Verification Report

PROJECT REFERENCE: GEO101021

REPORT NUMBER: 007 REPORT DATE: 01/06/2020

PROJECT: McAleer & Rushe

VERIFICATION ITEM TWO

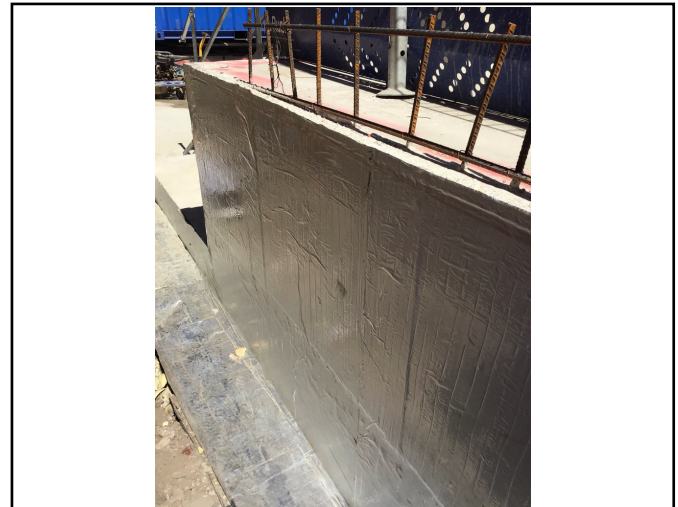
LOCATION/GRID LINE: West Toe Detail

NOTES: Gas Resistant Seal Adhesive Membrane has been

applied to the length of the western toe detail. A pick and probe test was carried out

on the overlaps to ensure that a good seal has been created.

Left photo) overview of Western Toe Detail, which as had GR SAM applied to it by the installers.

Right photo) GR SAM applied to Western Toe Detail.
